INFORMATION LETTER

407-21-124

TO: All owners and operators of model 407 helicopters

SUBJECT: THROTTLE CABLE ASSEMBLY 1608750-001, INTRODUCTION OF.

Figure 1 – Example of Failed Throttle Cable Assembly

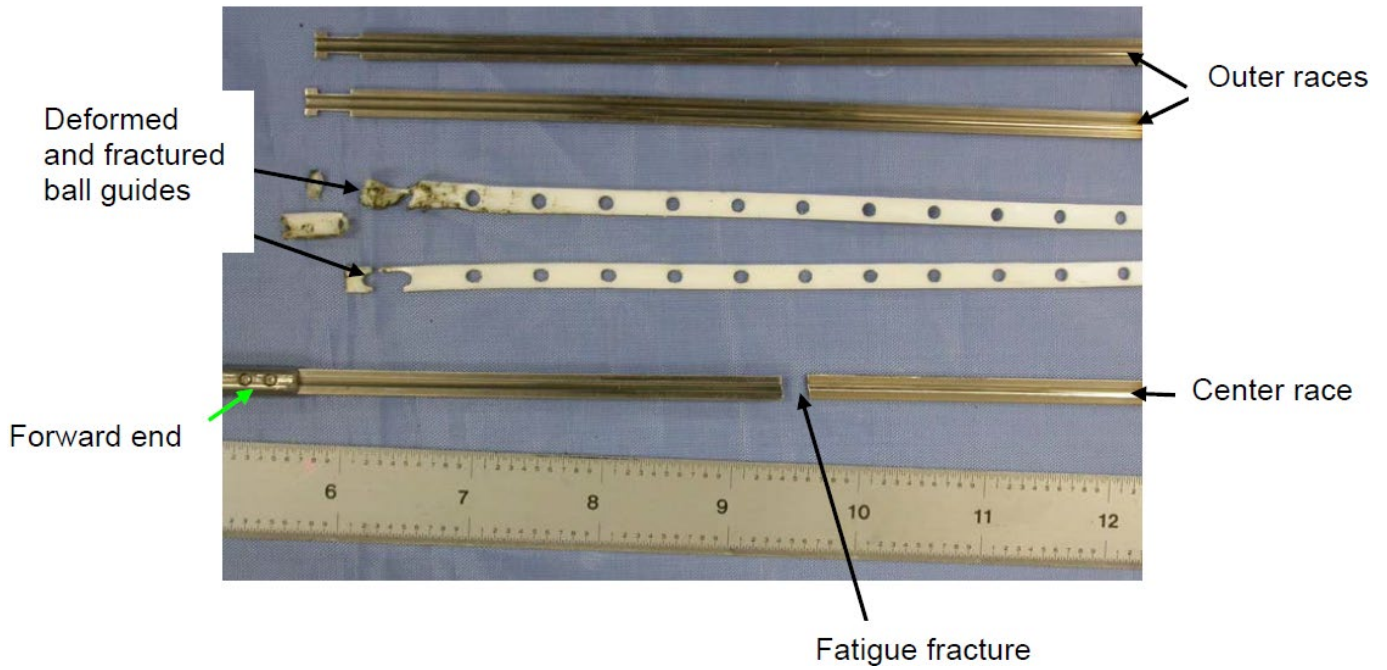
Following root cause investigations, several locations of the fractures of the center race material (Figure 1) occurred due to fatigue cracks that propagated over time. The majority of the failures occurred at the first bend under the pilot seat (Figure 2). During installation of the throttle cable assembly, it was noted that in certain areas the throttle cable assembly could have high stress loads applied, or kinked, while routing the cable assembly through the various areas of the airframe structure where the cable assembly could be exposed to high bend radii.

Figure 4 – Throttle Cable Assembly 1608750-001 Design Improvements (206L4 Installation Shown as Reference)

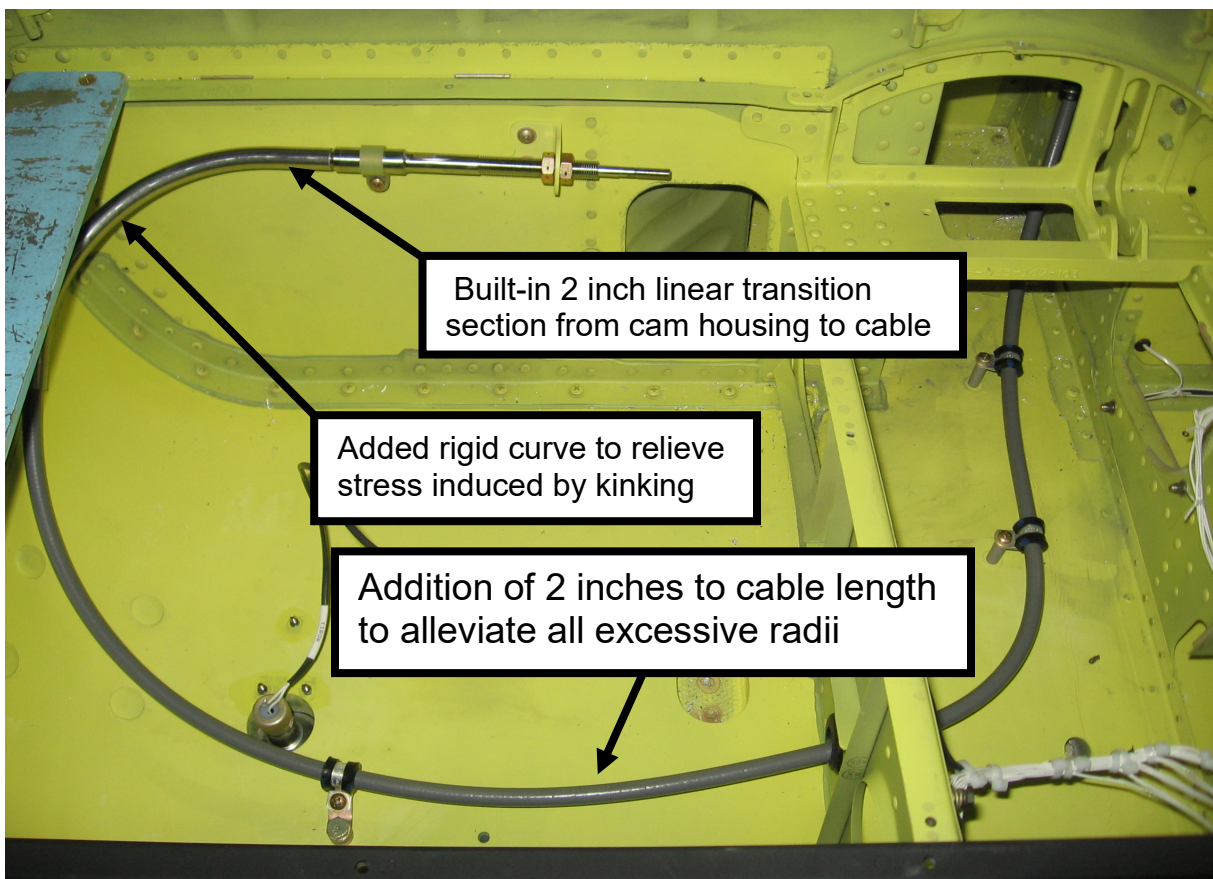
To minimize the possibility of future throttle cable assembly failures, Bell introduced the throttle cable assembly 1608750-001 into the production configuration of the 407 at serial number 54129 through 54166 (analogue 407) and 54388 through 54762 (407GX and 407GXP). In conjunction with the new design (Figure 4), improved installation procedures

[\(DMC-407-A-76-04-01-00A-720A-A\)](#) and handling procedures [\(DMC-407-A-76-04-01-00A-912A-A\)](#) were incorporated to the 407-MM Maintenance Manual.
